Bulletin | Danfoss Turbocor Compressors

B-CN-294-EN REV A

SUBJECT: TT Series AC/DC Cable Harness Color Changes

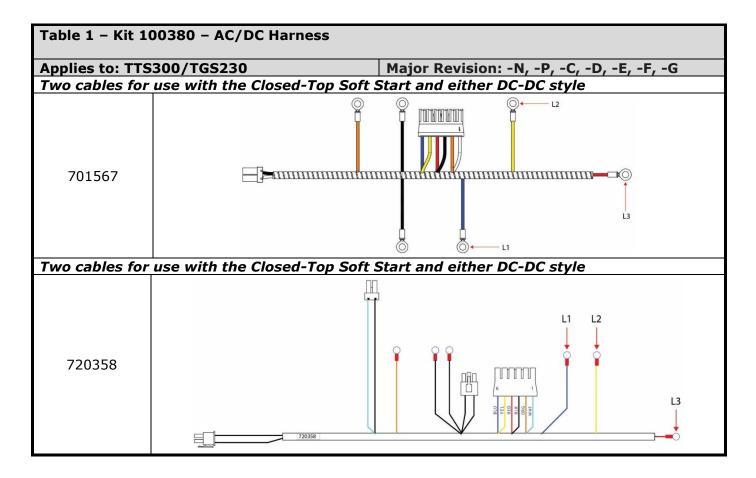
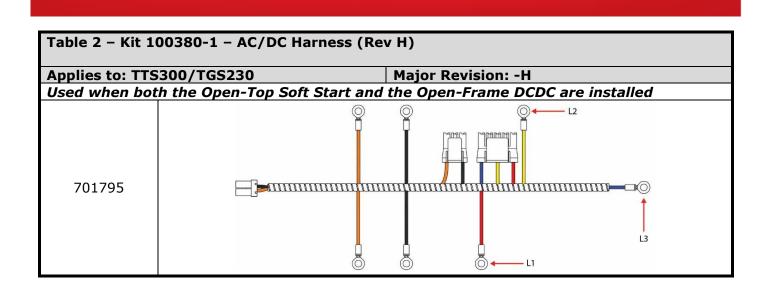
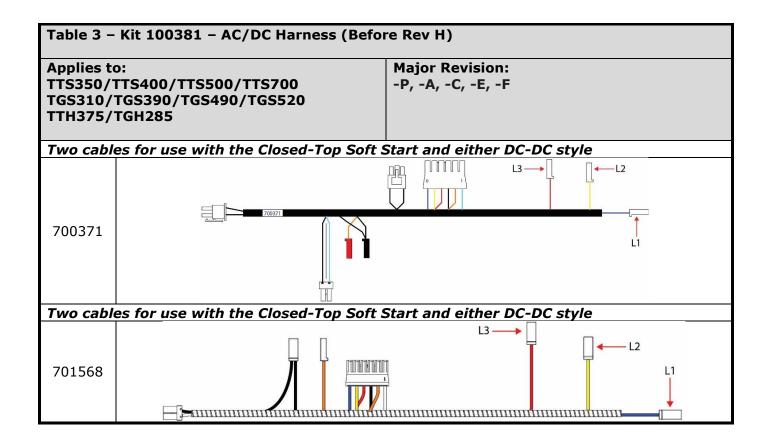
The purpose of this bulletin is to inform our customers that some TT Series AC/DC Cable Harnesses have had wire color changes. Specifically, the color of the L1 and L3 Connectors have <u>switched</u>. Refer to the examples in the tables in the Summary section when replacing these cables. All impacted replacement cables include labels at each connector.

The color of the L1 and L3 connectors on our TT Series AC/DC Cables have changed. The L1 wire color on pre-rev H cables is blue and the L3 wire is red. Our Rev H harness includes a red L1 wire and a blue L3 wire.

When changing the AC/DC harness, be sure to reference the tables above for the color change. Always match the label designation regardless of wire color.
